Intel Technical Advisory

TA-0899-2

Virtual Drive Expansion May Cause Physical Drives to be Marked Dead on the Intel® Modular Server System MFSYS25

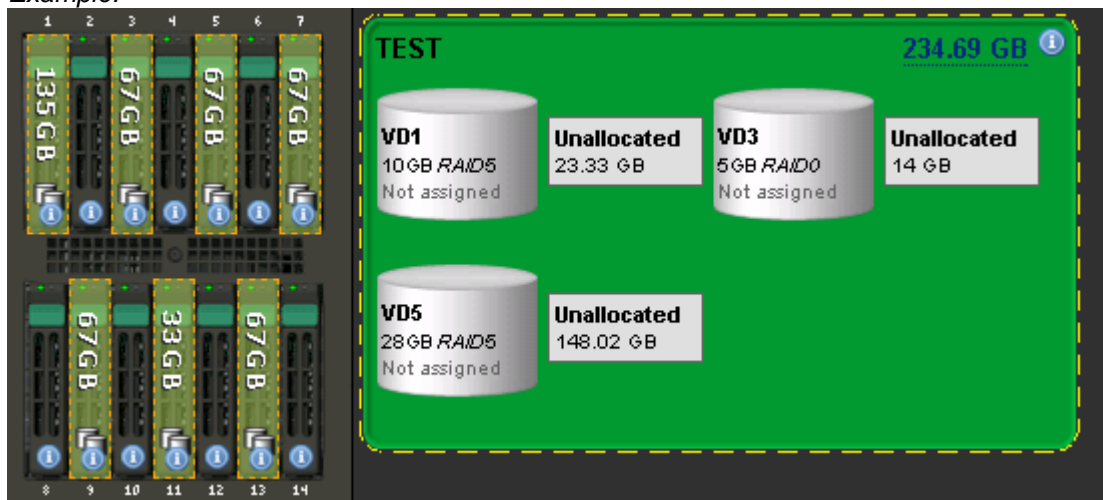
Expanding the capacity of a Virtual Drive within a Storage Pool by a size greater than the cumulative free unallocated space available after that Virtual Drive's position in the Storage Pool, will cause some or all of the Physical Drives to be marked Dead. This will result in all Virtual Drives within the Storage Pool going Critical or Offline and becoming unavailable. Once this occurs, the Virtual Drives and the data in them are NOT recoverable. Physical Drives can be recovered by deleting the Storage Pool, creating a new one, and creating new Virtual Drives.

In the configuration shown above, there is 185.35GB (23.33 + 14 + 148.02) of 'total unallocated space' in the entire storage pool. However, there exists only 162.02GB (14 + 148.02) of cumulative unallocated space **after** VD3's position in the Storage Pool. In this state, expanding the RAID0 Virtual Drive (VD3) by 170GB would result in this error condition. This is because there isn't 170GB of cumulative unallocated space remaining in the storage pool after this Virtual Drive's position in the Storage Pool (there is only 162.02GB (14 + 148.02) of cumulative unallocated space available after the Virtual Drive). Current software for the storage subsystem would allow this operation to proceed since there exists more than 170GB of total unallocated storage space within the entire Storage Pool. However, during the expansion of VD3, all Physical Drives in the storage pool would be marked as "Dead" and all virtual drives in the pool would be placed "Offline". The Storage Pool and all Virtual Drives within the storage pool would become unavailable and would NOT be recoverable.

When a Virtual Drive is expanded to include more space than the cumulative unallocated space available after its position in the Storage Pool, the Virtual Drive's expanded capacity is inaccurately calculated resulting in errors in how the data is rewritten to the Physical Drives. This causes the Physical Drives to be marked 'dead' which causes the Virtual Drives to be marked 'offline'.

Revision P 2.2.3 software for the Intel® Modular Server System MFSYS25 contains new firmware which corrects this issue. This software release is available for download from Intel's support website and is planned to be cut into factory production mid-June.
